ADDENDUM NO. 2

DATE: September 8, 2016
FROM: City of Grand Junction Purchasing Division
TO: All Offerors
RE: Construction and Site Work for the Las Colonias Park Amphitheater
IFB-4278-16-DH

4 SITE RETAINING WALL
1"=1'-0" 4.2

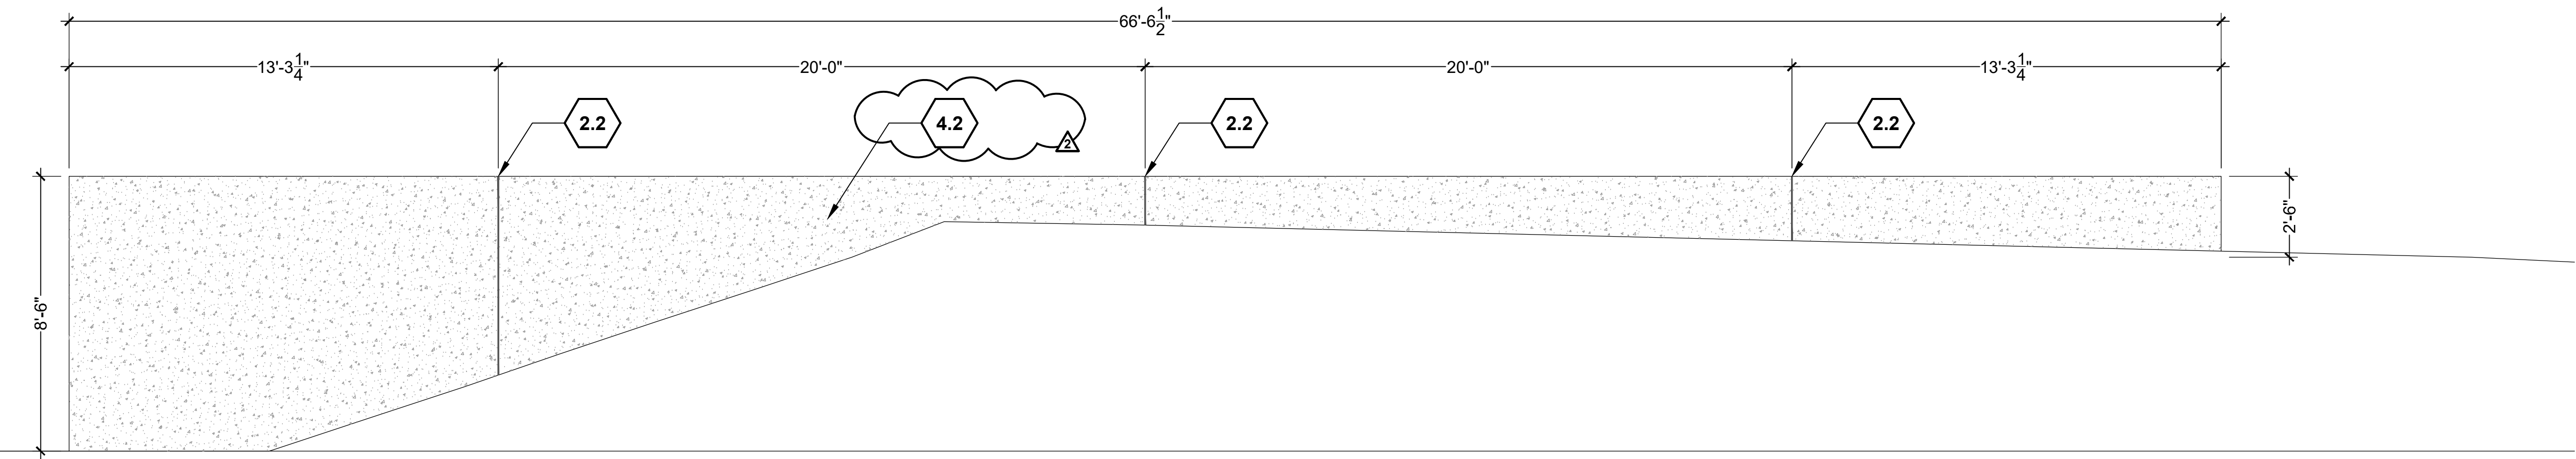
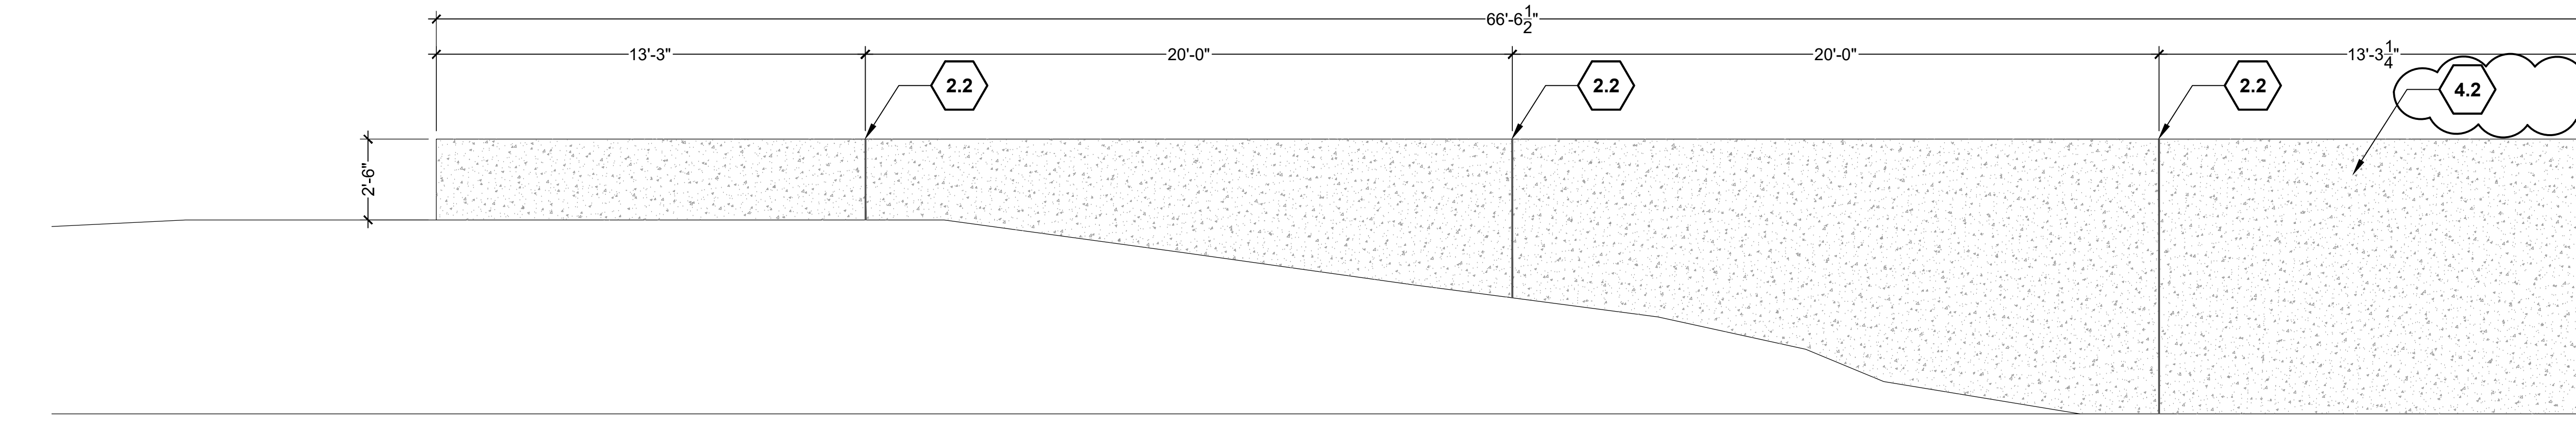
- A. It is not intended that any of the reinforcing bars be epoxy coated.
8. Q. Civil and Landscaping drawings indicate 18" concrete site walls but lack reinforcing, footing and bottom of wall elevation information. The structural drawings have a concrete retaining wall schedule and details for retaining wall reinforcing and footing but the schedule does not include an 18" thick wall and the wall designations (CRW) do not appear on any plans. Please provide reinforcing and footing requirements for the 18" wall and confirm this should be constructed with 5000 psi concrete per the structural notes on Dwg. S001. We are not familiar with a "3/4" Toweled Bevel" called for on this wall, please provide section detail.

- A. The site wall in the amphitheater remains tied to detail 4.1. The minimum reinforcement for an 18" thick x 30" maximum height wall is #4 rebar at 16"oc each face vertical and #5 at 12"oc each face horizontal. The footing size should be 3'-0" wide x 12" thick x cont. reinforced with (3) #5 bars x cont. lengthwise and #5 x 2'-6" bars at 14"oc crosswise.

The second site wall has been revised to detail 4.2 and as a 10" wall thickness. The structural wall schedule on Detail 8, Page S601 has all applicable reinforcing and footing details. The revised layout will assume the same center line as the previous design width of 18".

The detail contains a typo error. Please replace "3/4" Toweled Bevel" with "3/4" Chamfered Edge."

sheet:
MH103

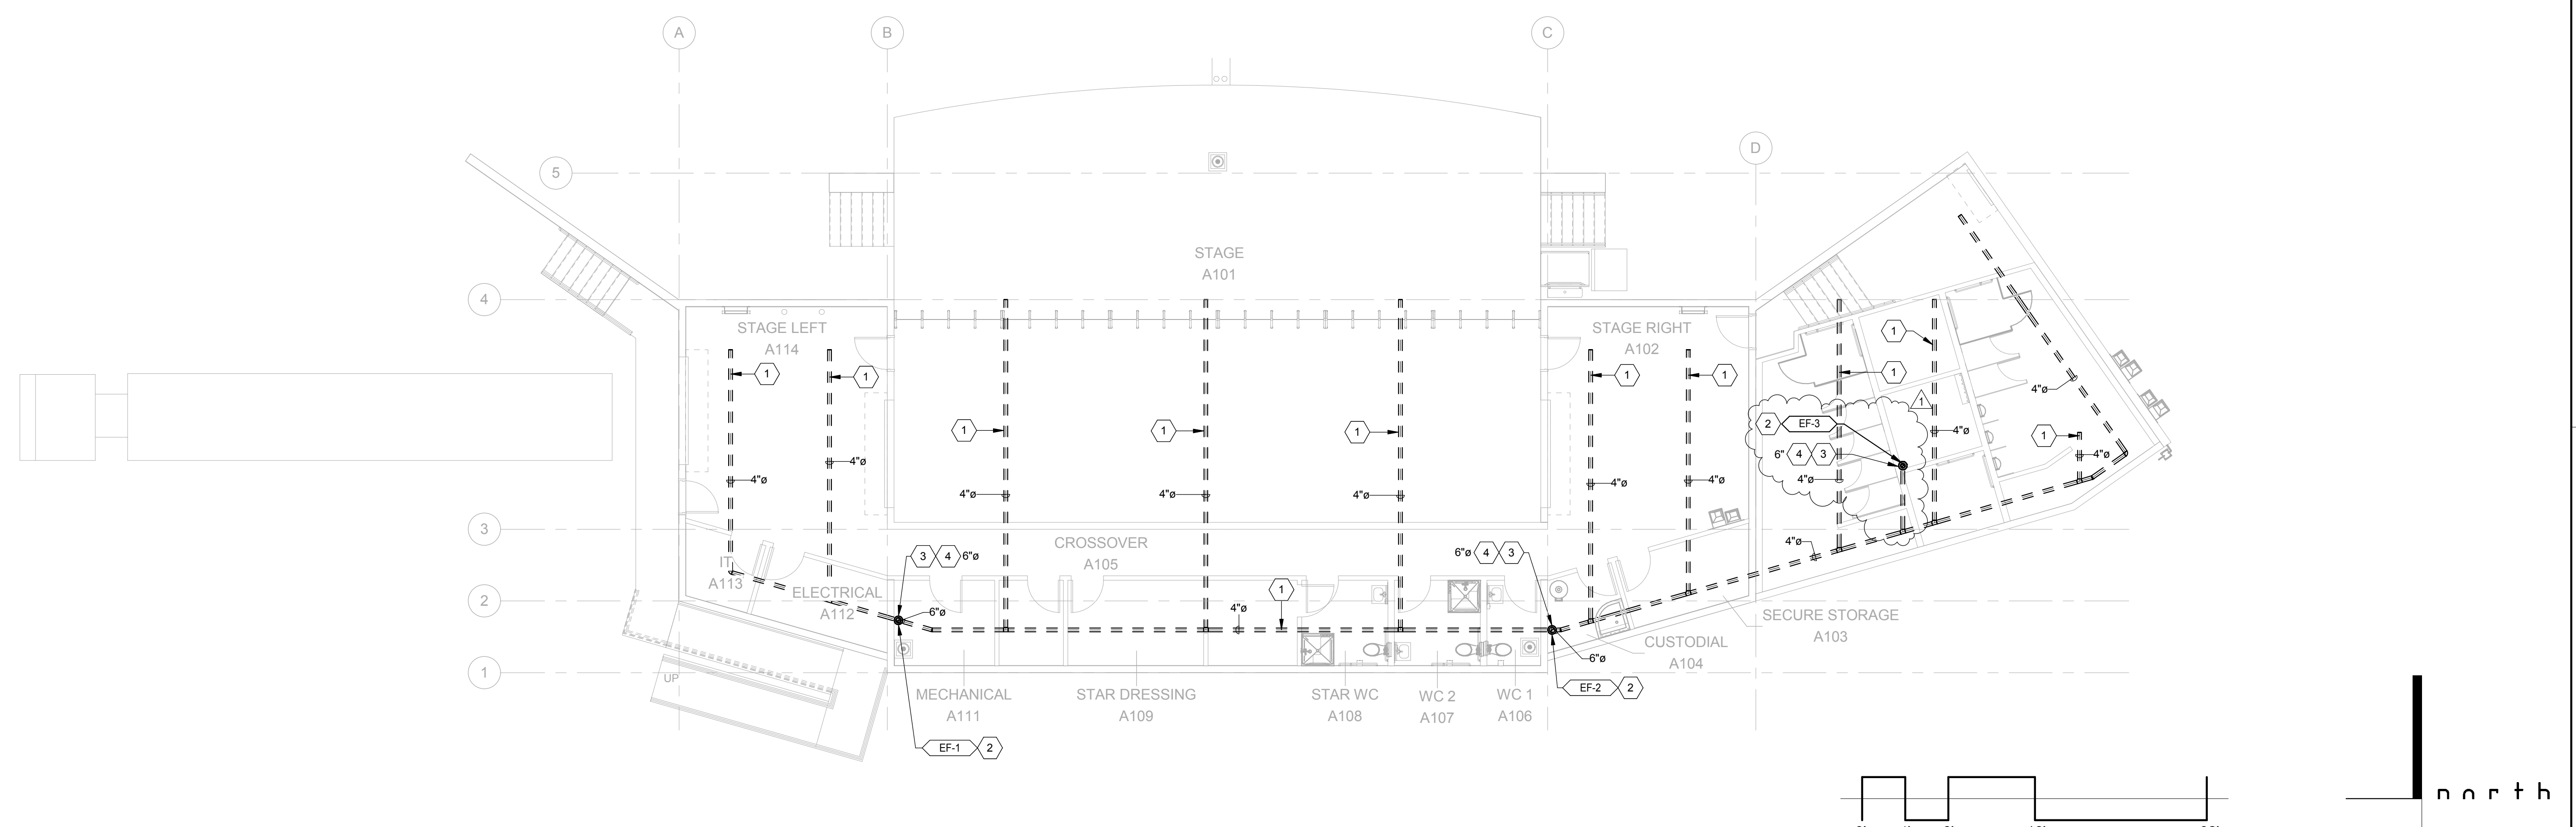
39. Exhaust fan EF-3 does not have a monitor on the vent pipe like EF-1&2, nor is the pipe shown on the roof plan. Will EF-3 need to be tied in to the radon piping system?

A. EF-3 is shown tied into the radon piping system. Provide radon u-tube monitor (in mechanical room) and extend through roof. Offset piping in attic space and coordinated exact location with ERV unit. **See revised drawings MH103 & MH104.**

sheet:
PL101

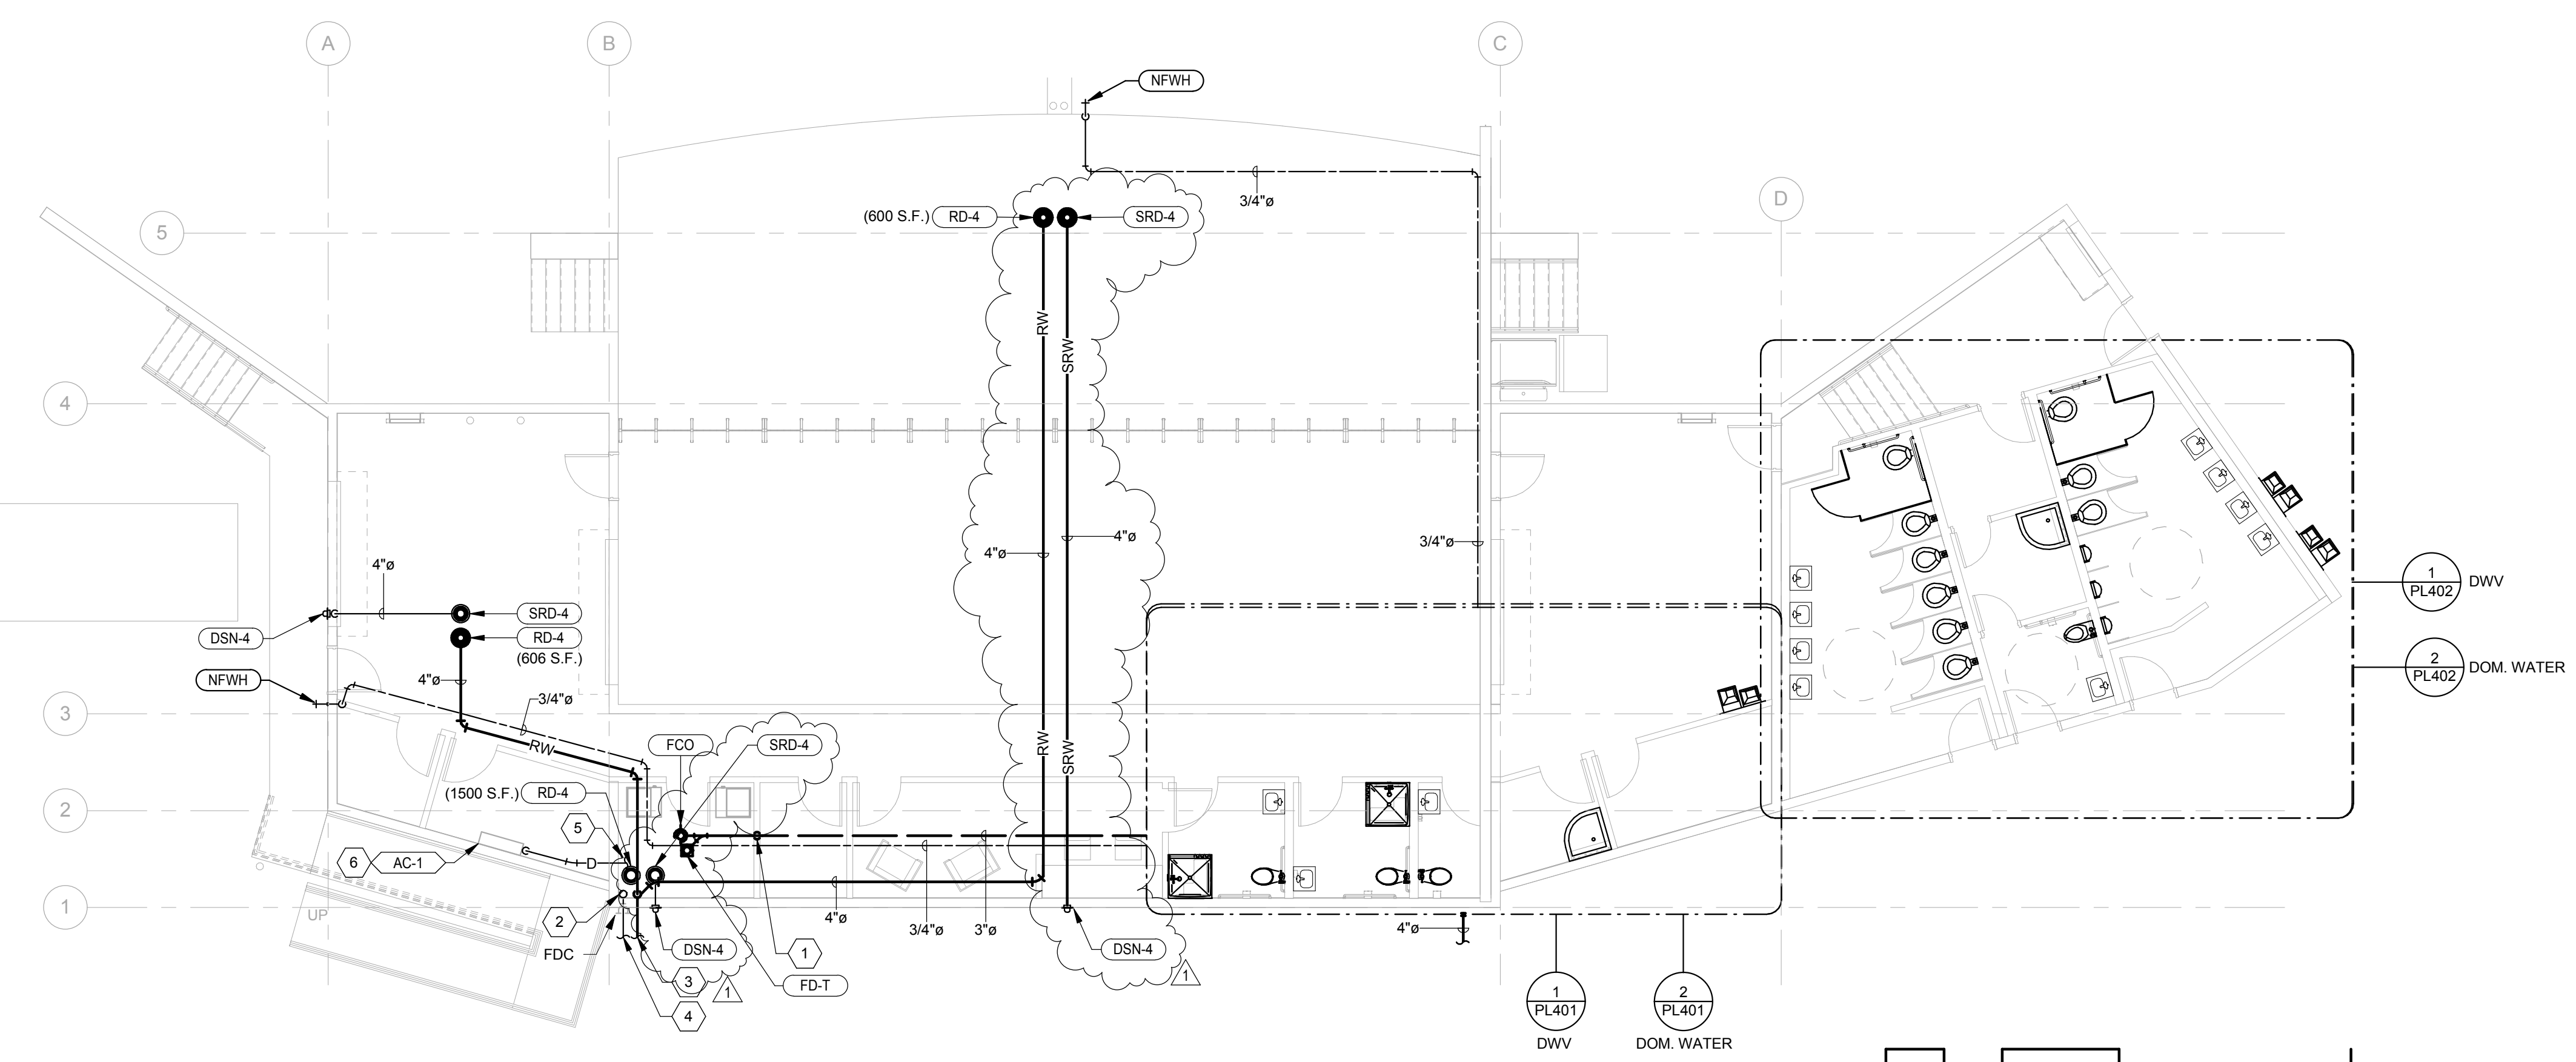
41. Plan AE102 shows a roof drain (RD) & secondary roof drain (SRD) at Grid line 5, sheet PL101 shows only the RD and piping. Please confirm if an overflow roof drain is need at this location and where the downspout is to be located.

42. PL101 There are 2 additional roof drain location along Gird Line 1 that the plumbing plans only show the roof drain and have no overflows called out. Please confirm.

A. A Secondary roof drain ""SRD-4"" should be provided adjacent to "RD-4" at grid 5 (between grid B & C., as shown on the roof plan AE102). A 4" secondary rain water pipe should extend from the "SRD-4" and run parallel to the 4" rain water pipe and extend through the exterior wall at grid 1 and terminate, near the roof, with a downspout nozzle "DSN-4". **See revised drawing PL101.**

A. A Secondary roof drain "SRD-4" should be provided adjacent to "RD-4" at grid B-1 and, at grid C-1. (2 locations). A 4" secondary rain water pipe should extend from the ""SRD-4"" and extend through exterior wall at grid 1, near the roof, and terminate with a downspout nozzle "DSN-4". **See revised drawing PL101 & PL401.**
